Service Bulletin

Subject: Introduction of Grease Nipple (lift tube)

Date: February 2021

New Grease Nipple Location

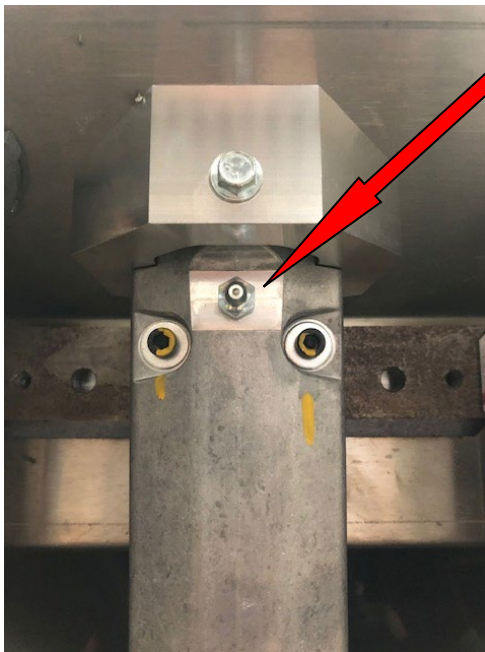
As Part of Garlands continuous improvement program we have introduced the ability to lubricate the actuator shaft and lift TUBE without the requirement to dismantle the shaft and tube assembly.

The grease nipples were introduced into production grills from serial number 20061001XXXXX (June 2020)

New grease nipple location, one per shaft tube.

Please ensure only Garland approved grease is used, you have 2 options when greasing the shafts.

You can use the current 100ml tubes of Garland grease or purchase 750ml (375 gram) tubes of Nevastane XMF2 grease which is made by Total and approved by Garland for use on all grills.
